8495D-02

Modification Recommended Service Note

8495D – Manual Step Attenuator

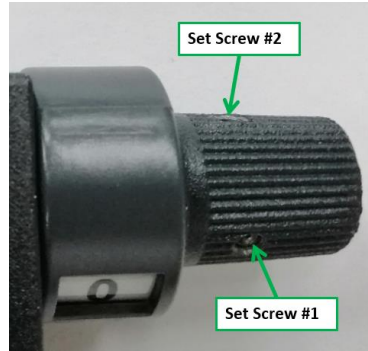
The attenuation knob was not securely tightened to the internal shaft, causing it to turn further. This is due to an insufficient torque that was applied to tighten the set screw during assembly at the factory.

This issue can be fixed by re-tightening the screws on the rotating knob.

- (1) Rotate the knob clockwise until it reaches the last attenuation step, which is at 0 dB.
- (2) Loosen the 2 set screws (0.05" Hex screw bit) on the knob slightly until the knob can freely move, and then align the knob so that the indicator label number "0" is located at center on dial cover window.

- (3) Tighten both set screws with a 0.05" Hex screw bit and 4.0in-lbs torque driver.

(4) After tightening both set screws, rotate knob counter-clockwise until it reaches the maximum attenuation (11/70/110dB). To ensure the attenuator functions properly, rotate the knob clockwise back to minimum attenuation (0dB), and repeat the movement for 10 cycles.
